P/2017/0482

AMENDED
PLANNING DEPARTMENT

BLOCK PLAN PROPOSED

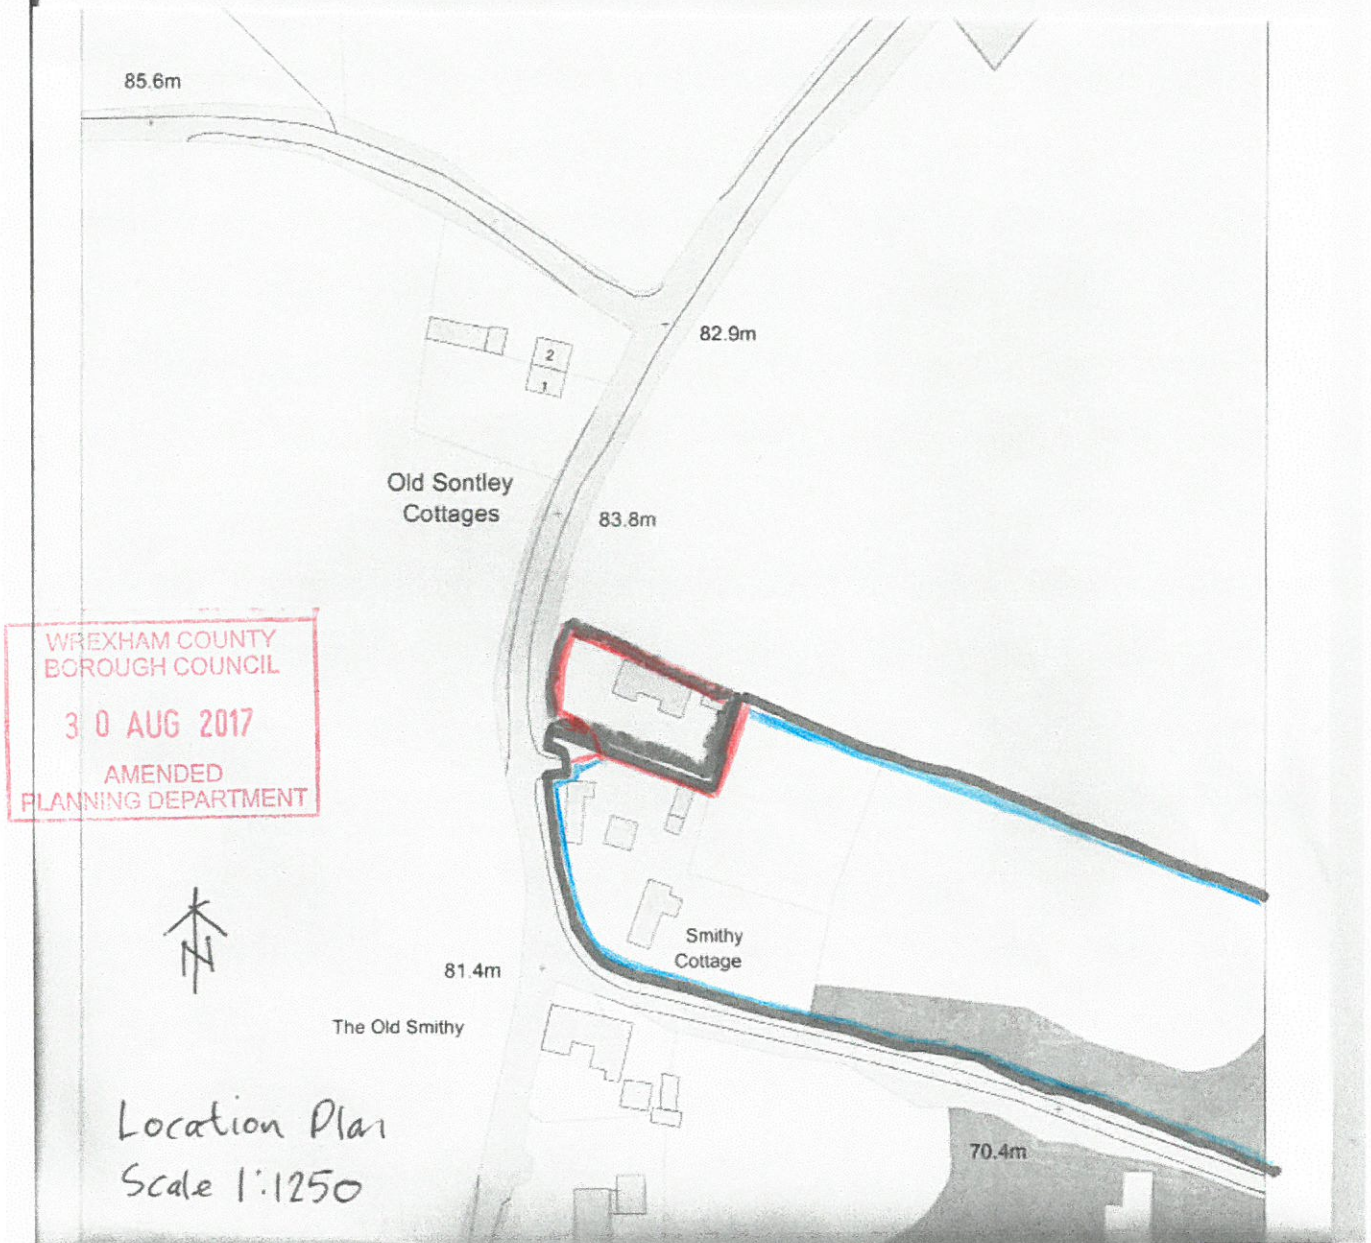
25/8/17. Site Plan to
show changes to
Site with new access
changes for stables using
modified existing access.
As requested by highways

25/8/17. Block Plan to reflect changes requested by highways in relation to parking & turning.

Gate 5m from highway and mit 3.6m wide

Wall rebuilt to suit splay

Hedge removed to suit splay
